**NO:** LC-066      **PRODUCT:** F3SG-RA Safety Light Curtains  
**DATE:** February 2017      **TYPE:** Modification Notice

## F3SG-RA Series Safety Light Curtains Will Be Modified for More Space Efficient Mounting

## Mounting in Top/Bottom Adjustable Bracket (F39-LGTB)

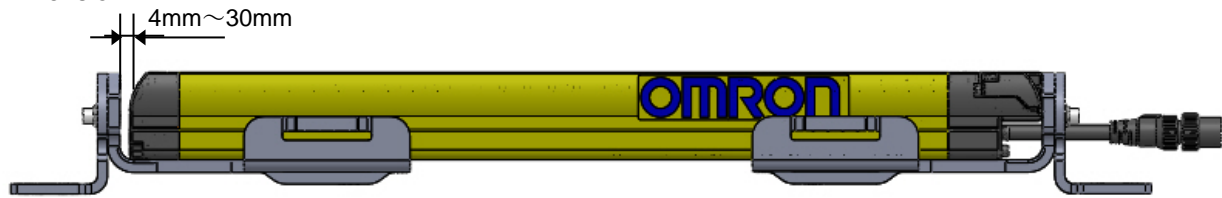
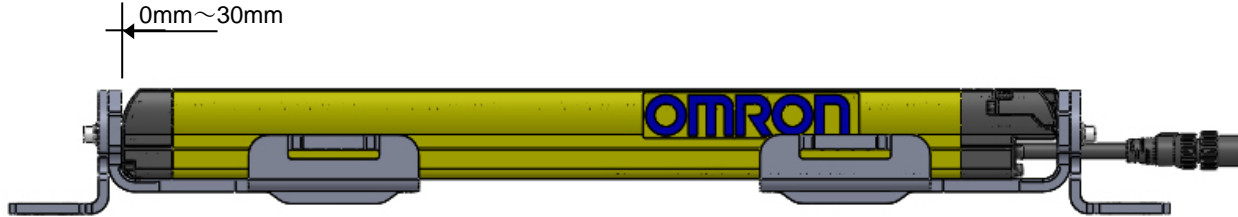
**Reason for modification:** Modified F3SG-RA can be mounted flush against the top of adjustable mounting bracket F39-LGTB. Previous versions required a minimum 4 mm head space.

### Before the change

Minimum 4 mm headspace required.

### After the change

No minimum headspace required
